Access Compliance Report

Public Rights-of-Way

Intersection ID: 30455	Main Street: HARMONY_GLEN_CT	Cross Street: WALLAND_LN	Location: NW
ADA ID: 9237B18E1A85	Ramp Type: BlendTrans2	Initial Pass/Fail: Fail	Overall Compliance: No
Severity Score: 8.75			
Codes/Mitigation Info/Possible Solution		Field Measurements/Component Compliance

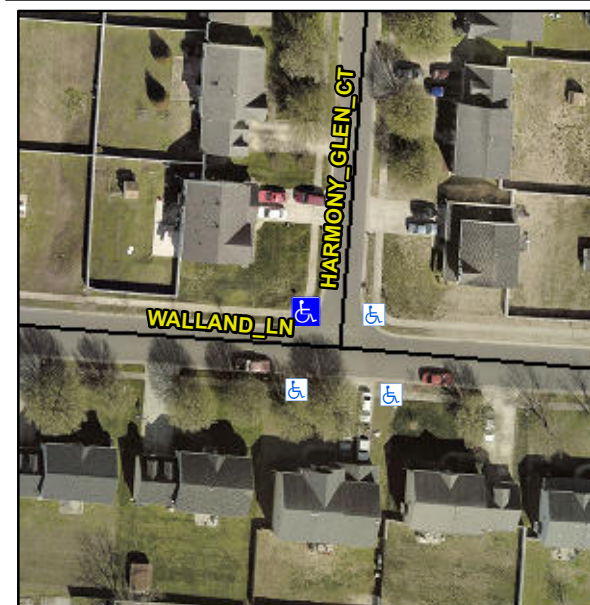
R304.5.1

Compliance	Description	Data	Compliance	Description	Data
N/A	Ramp Length (in)	95.0	Yes	BlendTrans Slope (%)	3.1
No	Ramp Width (in)	46.0	Yes	BlendTrans XSlope (%)	0.1
N/A	Flare Type LT	N/A	N/A	Flare Type RT	N/A
N/A	Flare Slope LT (%)	N/A	N/A	Flare Slope RT (%)	N/A
N/A	Flare Traversable LT?	N/A	N/A	Flare Traversable RT?	N/A
N/A	Landing Length (in)	N/A	N/A	DWS Provided?	N/A
N/A	Landing Width (in)	N/A	N/A	DWS Contrast?	N/A
N/A	Landing Slope (%)	N/A	N/A	DWS Length (in)	N/A
N/A	Landing X Slope (%)	N/A	N/A	DWS Full Width?	N/A
N/A	Landing Curb? (Y/N)	N/A	N/A	DWS Offset (in)	N/A
N/A	Shared Landing?	N/A			
N/A	Gutter Ponding?	N/A	N/A	Gutter Slope (%)	N/A
N/A	Gutter Lip Ht (in)	N/A	N/A	Gutter X Slope (%)	N/A
N/A	Painted X Walk1?	No	N/A	Painted X Walk2?	No
	X Walk 1 Direction	To S		X Walk 2 Direction	To E
	X Walk 1 Width (in)	N/A		X Walk 2 Width (in)	N/A
	X Walk 1 Slope (%)	0.7		X Walk 2 Slope (%)	1.1
	X Walk 1 X Slope (%)	0.8		X Walk 2 X Slope (%)	2.6

Remove & Replace Curb Ramp With Two New Directional Ramps or Equivalent.
